REVISED FINAL FOUNDATION REPORT

Camino Capistrano Undercrossing (Widen)
Bridge No. 55-0227L
Orange County, California
12-ORA-5, PM 7.4
Caltrans Project No. 1200020279 (EA 12-0F96E4)
EMI Project No. 11-137
Date: January 23, 2013

Earlier versions of this report dated April 23 and October 5, 2012 were submitted to Caltrans for review. OGDS-1 review comments were provided in memorandums dated August 31, 2012 and January 4, 2013. EMI responses to OGDS-1 comments were reviewed by the Caltrans Oversight Geo-Professional Dr. Sharid Amiri at the over-the-shoulder review meeting conducted at the EMI office on September 20, 2012 and January 9, 2013. The EMI oversight engineers, Mr. Lino Cheang and Mr. Raja Pirathiviraj on September 20, 2012, and Mr. Andrew Korkos, Mr. Mike Kapuskar and Mr. Raja Pirathiviraj on January 9, 2013, were the attendees of the meeting. Responses to Caltrans comments have been incorporated into this Foundation Report. Caltrans review comments, EMI responses, and email correspondences are provided in Appendix D.

The Office of Geotechnical Design South 1 (OGDS-1) has reviewed the submittal titled “Revised Final Foundation Report for Camino Capistrano Undercrossing (W

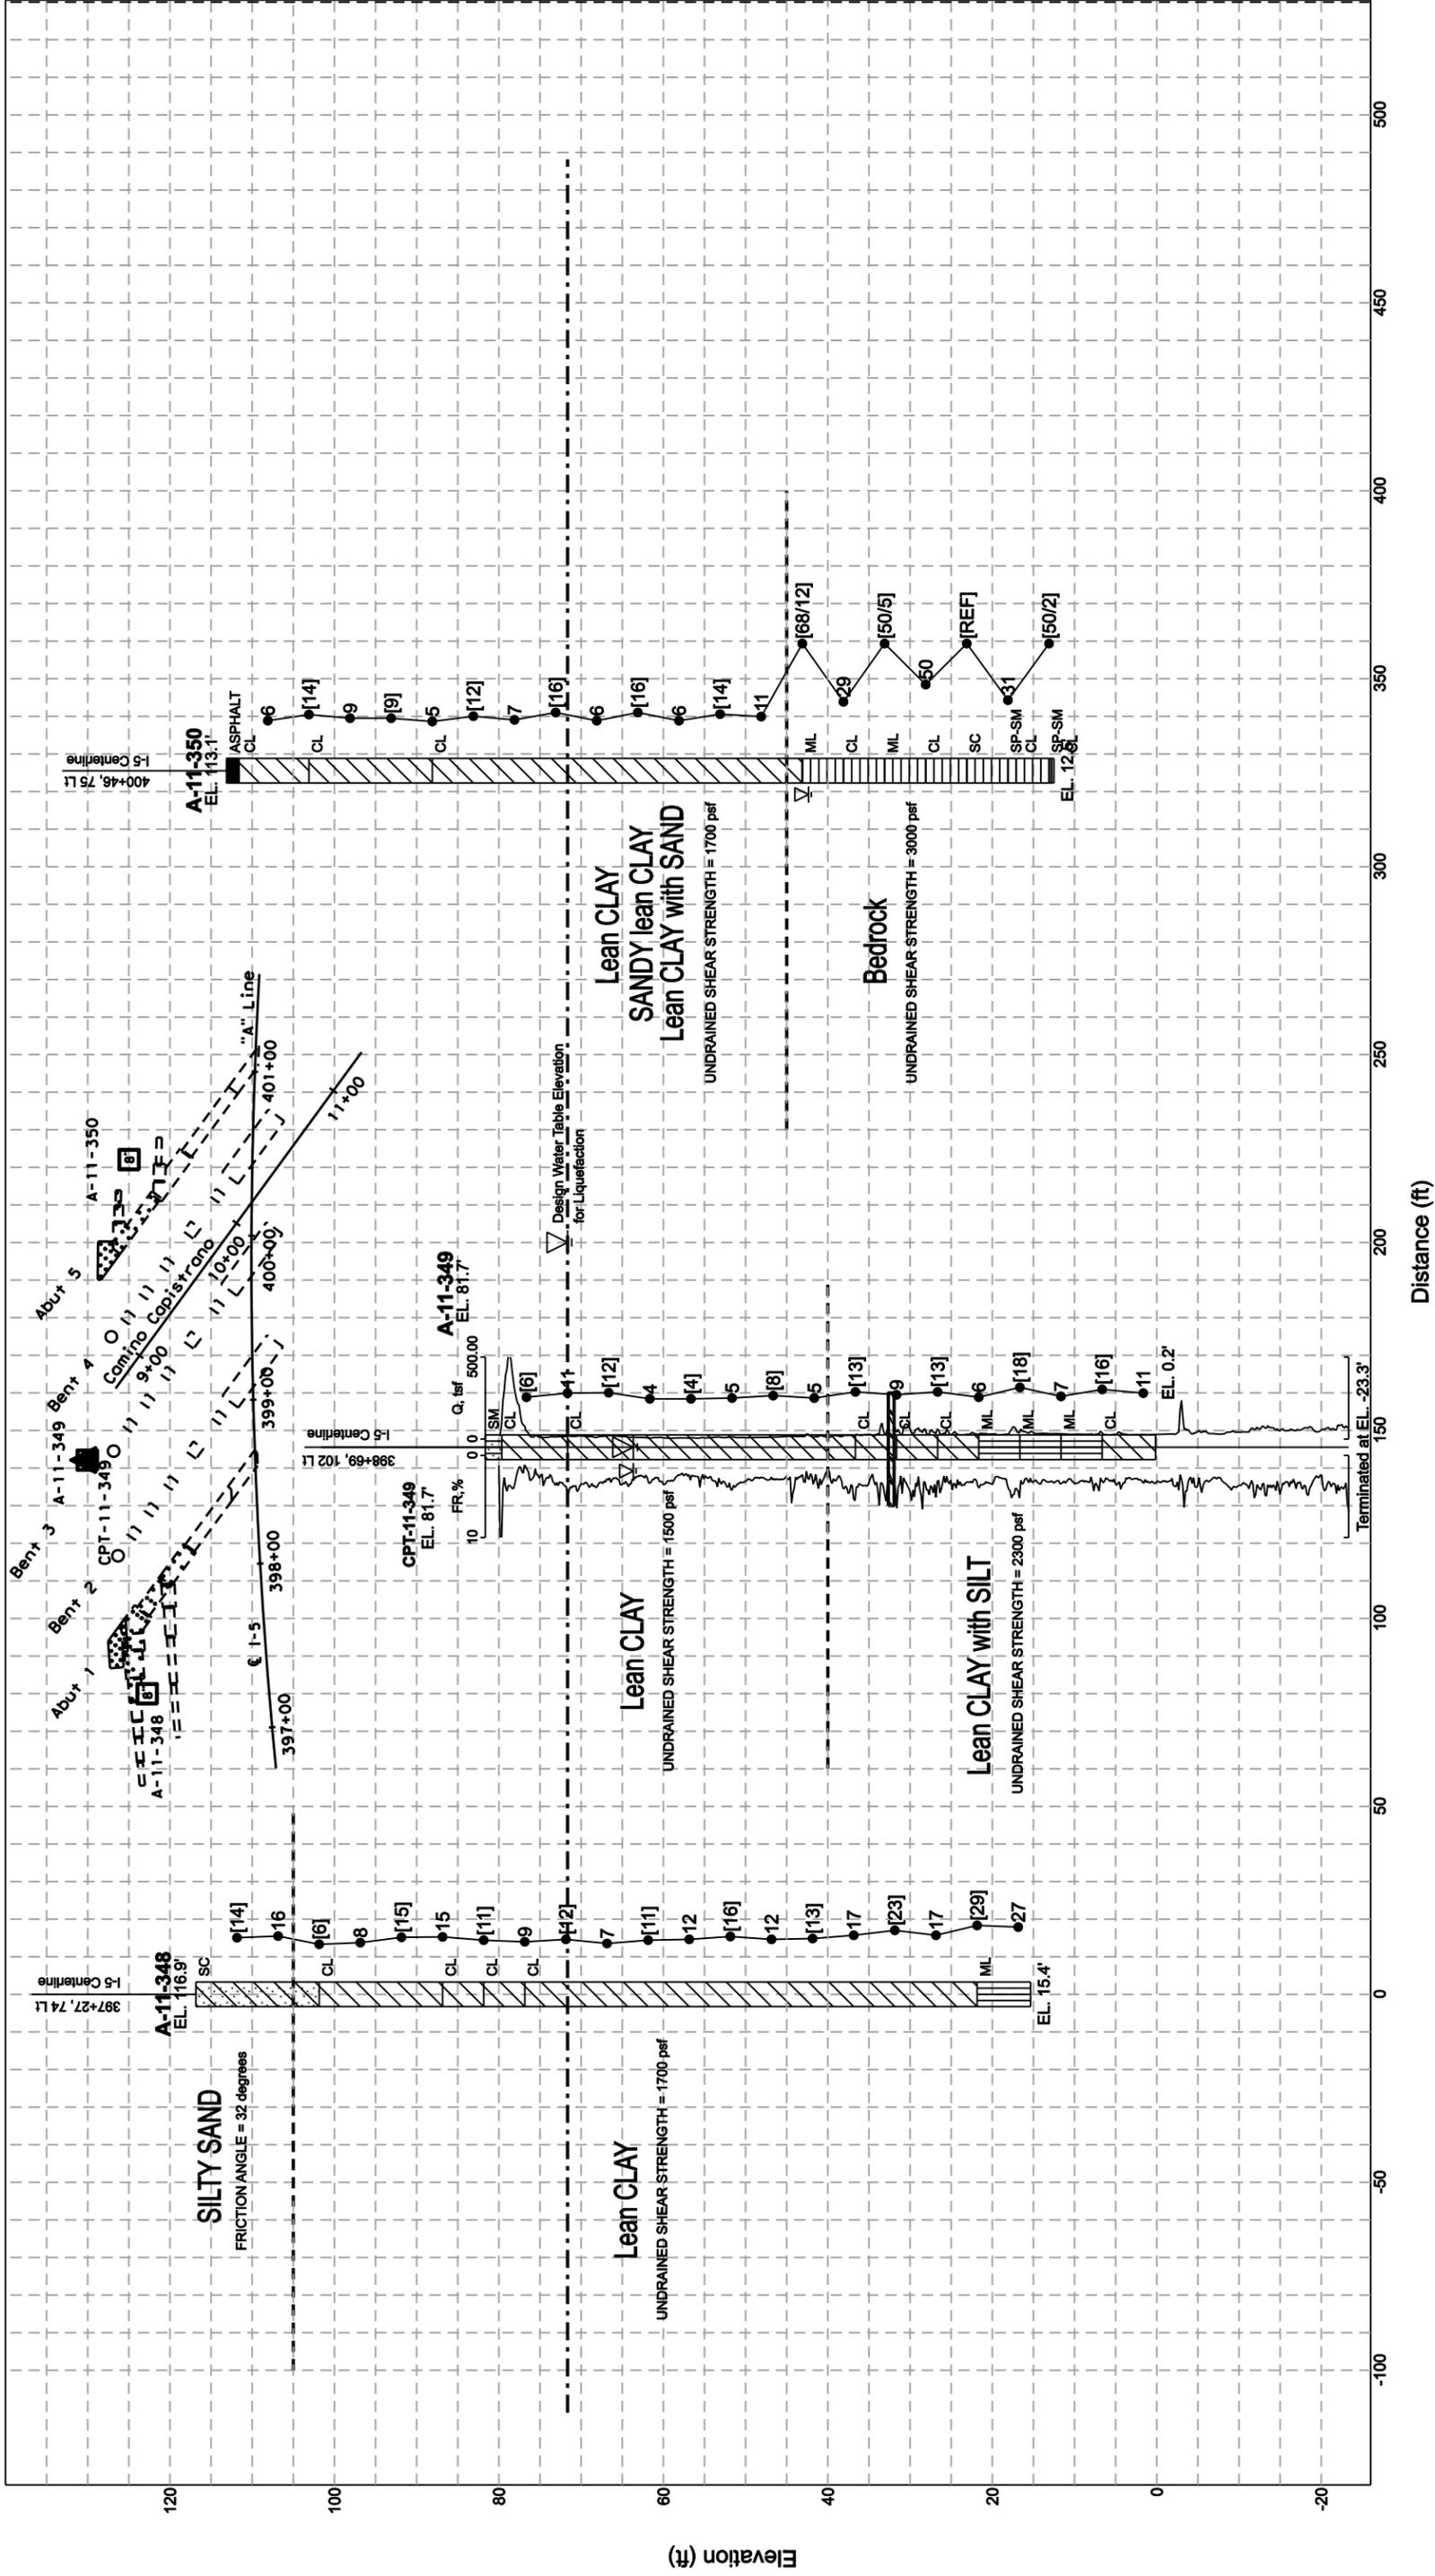
12. *Revise the Idealized Soil Profile to include station line.*

“Figure 4-1 Idealized Soil Profile” showing the idealized soil profile with the station line, will be added to Section 4.2 of the report.
